PROPOSED REVISIONS
TO
PLANNING BOARD'S
SUBDIVISION

RULES &
REGULATIONS

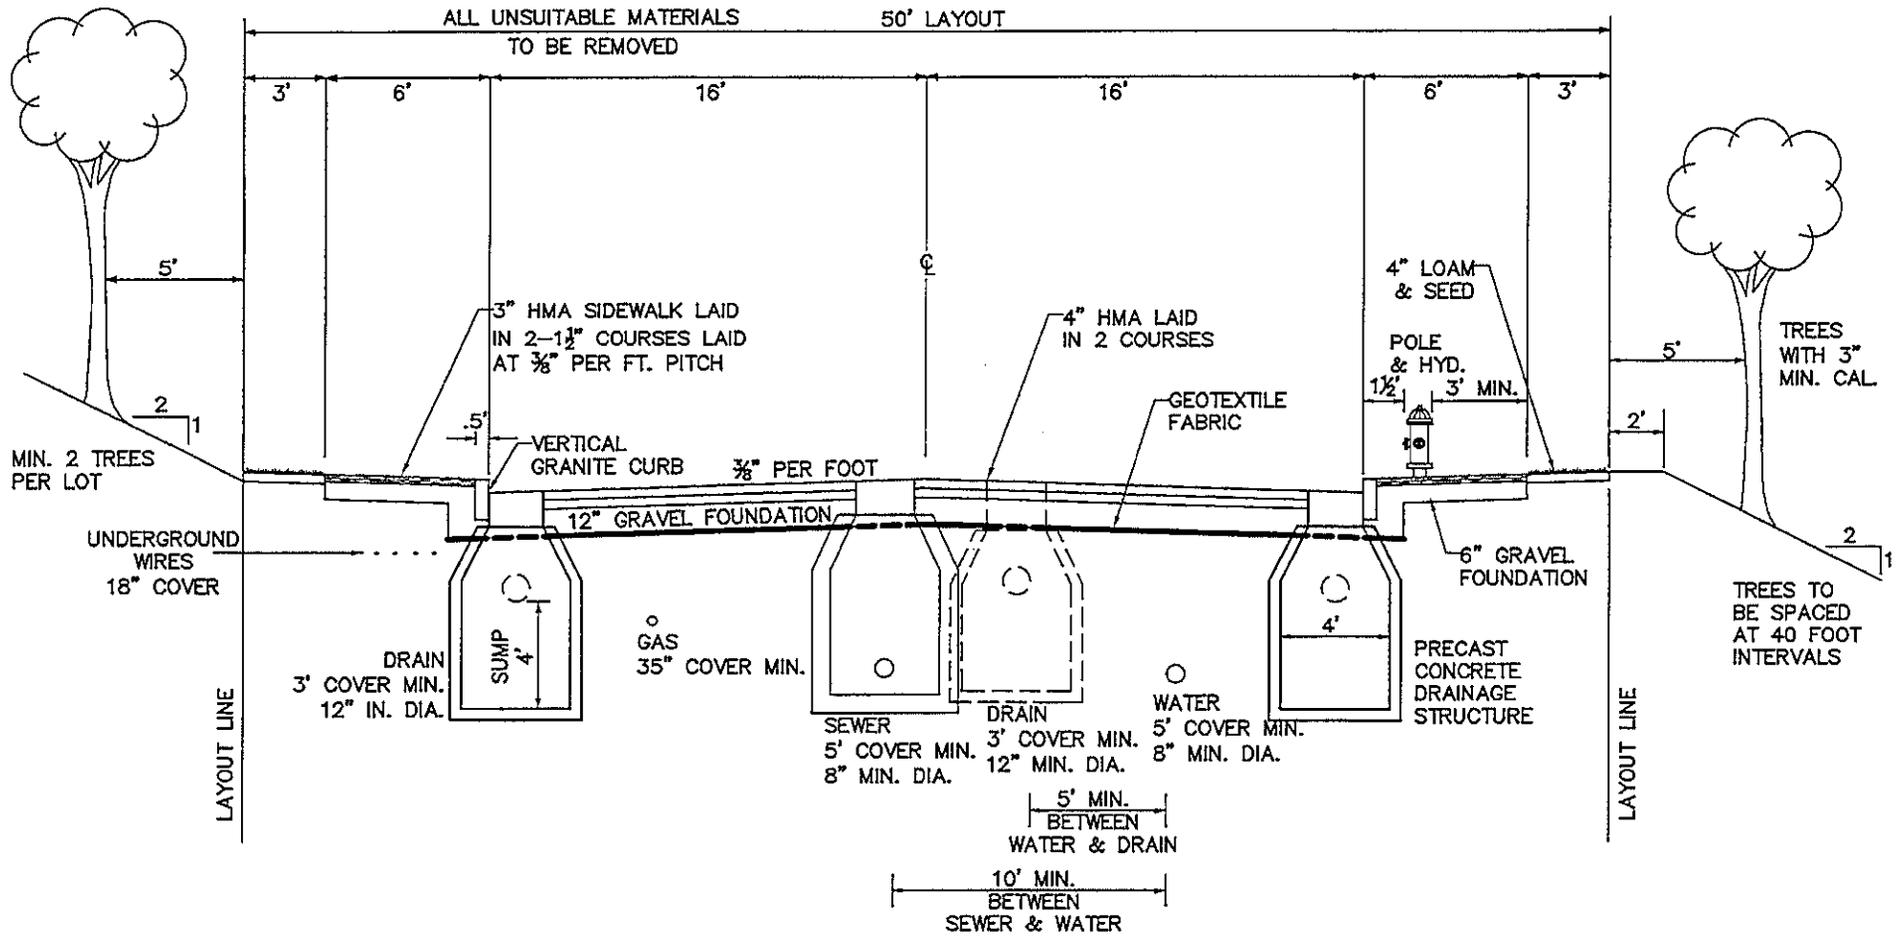
Section 676-26.B - 700. Bituminous concrete sidewalks having a minimum thickness of ~~two~~ three inches after compression shall be constructed on a six-inch gravel foundation to the required lines and grades in accordance with these specifications. The sidewalk shall be constructed with a ~~sloped~~-vertical granite curbing or as approved by the Commissioner of Public Works.

ALTERNATIVE STANDARDS
N.T.S

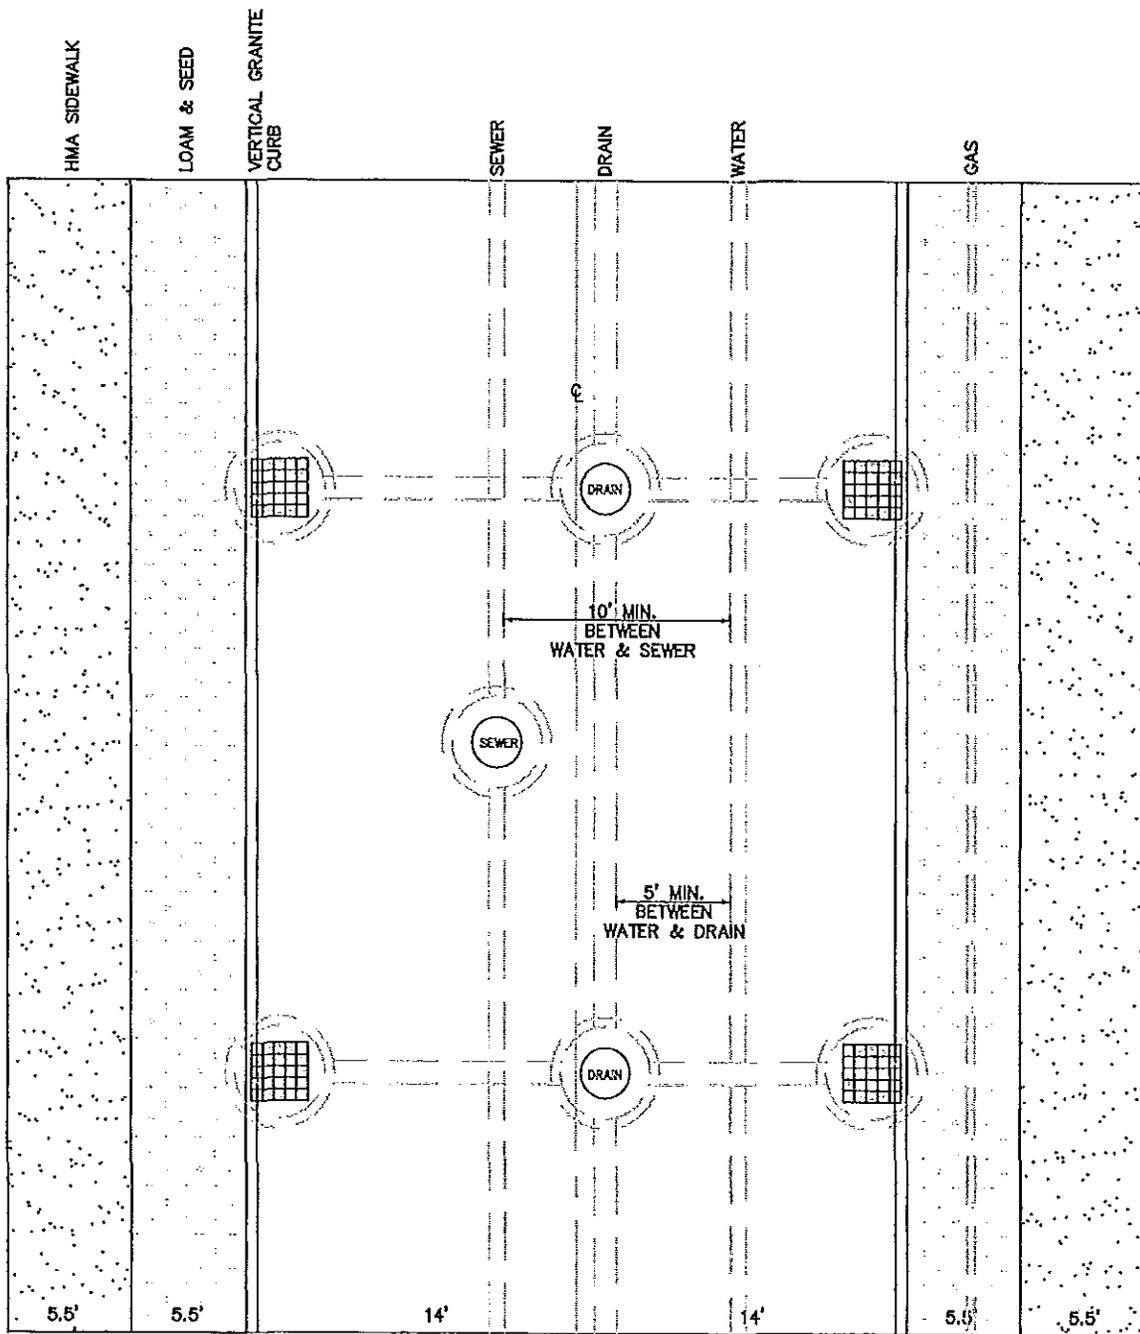
Section A676-23.A **General.** No street or way through private property shall be accepted by the City unless the same be previously constructed and completed in accordance with the standard cross section (see Appendix F, on file in the office of the City Clerk, at Cross Section #6), street layout plan, profile and the following:

TYPICAL SECTION FOR WHEELCHAIR RAMPS AT SIDEWALKS

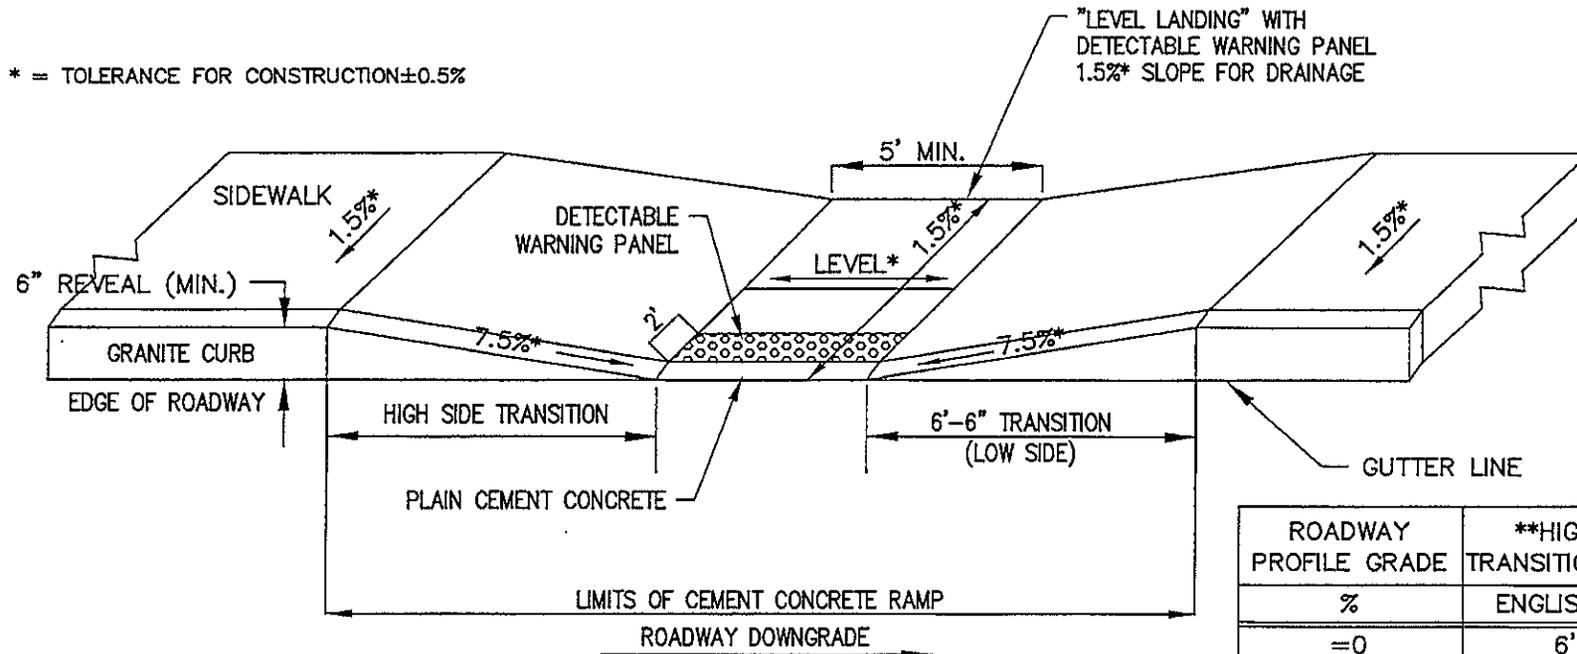
Section A676-13.C. Wheelchair ramps shall be provided as shown in Appendix I of this chapter.

[Appendix I, on file at the office of the City Clerk, has been updated to reflect current ADA standards.]

MAILBOX INSTALLATION
TYPICAL SECTION

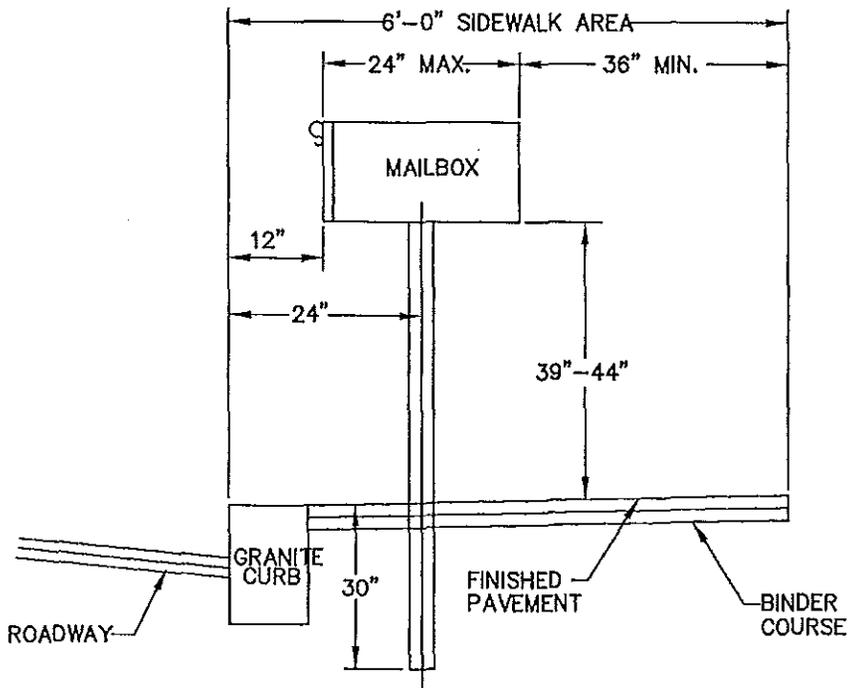
Section A676-37. Mailboxes shall be installed in accordance with Appendix J.

[Appendix J, on file at the office of the City Clerk, has been updated to reflect a proposed Rules and Regulations revision from sloped granite to vertical granite.]
